Work Order ID 154366

Item Name: Baggage Compartment Protector - Floor

DART SERVICE INSTRUCTION

TO AMEND INSTALLATION INSTRUCTIONS IIN-D407-781-2 REV. A OR LATER APPROVED REVISION
AND INSTRUCTIONS FOR CONTINUED AIRWORTHINESS ICA-D407-781 REV. 3 OR LATER REVISION

**FIGURE 1 - D3879-1 BAGGAGE COMPARTMENT WALL
PROTECTOR - ALTERNATE INSTALLATION**

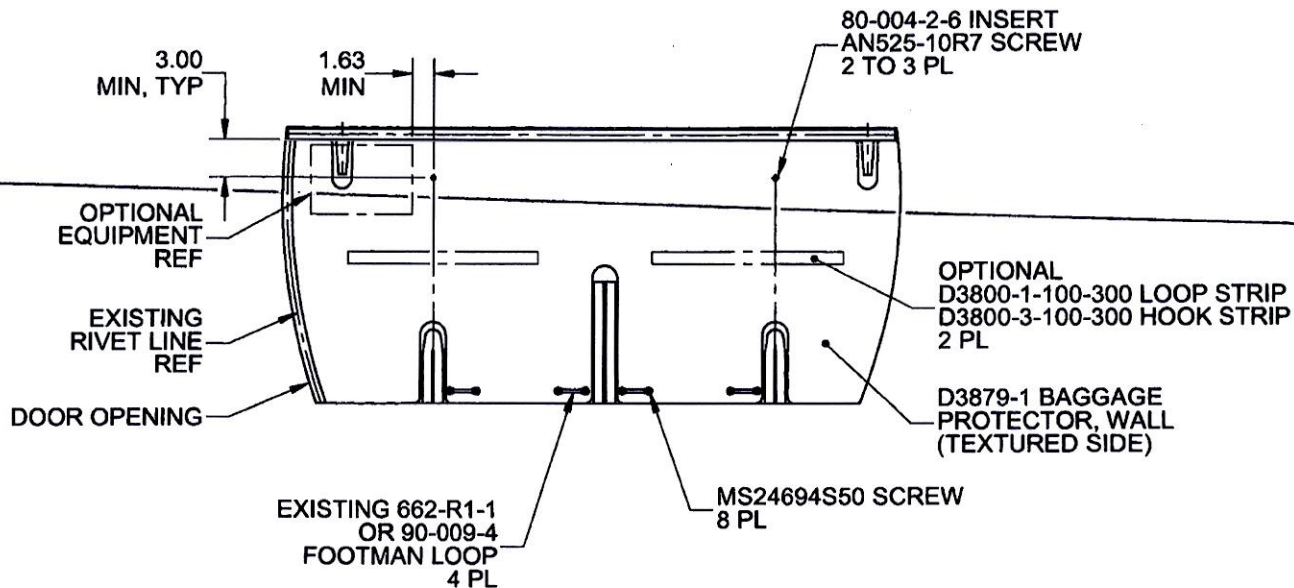
In some aircraft, the top portion of the D206-781-041 Baggage Compartment Wall Protector Kit cannot be installed as indicated in IIN-D407-781-2. The purpose of this DSI is to provide an alternate mounting method to fasten the top portion of the D206-781-041 Baggage Compartment Wall Protector Kit.

It is acceptable to replace qty(2) D3930-1 Clips with qty(2) 80-004-2-6 Inserts. Locate and mark location of the two attachment holes on the baggage compartment wall as shown in Figure 1 of this service instruction. Install 80-004-2-6 Inserts at the marked locations in accordance with Section 3-2-12 of BHT-206-SRM-1. It is acceptable to trim the wall protectors to accommodate optional equipment or transfer attachment holes to the wall protector and install the optional equipment on top of the wall protector with longer fasteners.

Amend the D206-781-041 Baggage Compartment Wall Protector Kit parts list as follows:

Qty -061	Qty -031	Qty -041	Part Number	Description
X			D206-781-061	BAGGAGE COMPARTMENT PROTECTOR KIT (FLOOR AND WALL)
1	X		D206-781-031	BAGGAGE COMPARTMENT FLOOR PROTECTOR KIT
1		X	D206-781-041	BAGGAGE COMPARTMENT WALL PROTECTOR KIT
		2	AN525-10R7	SCREW
		2	80-004-2-6	INSERT
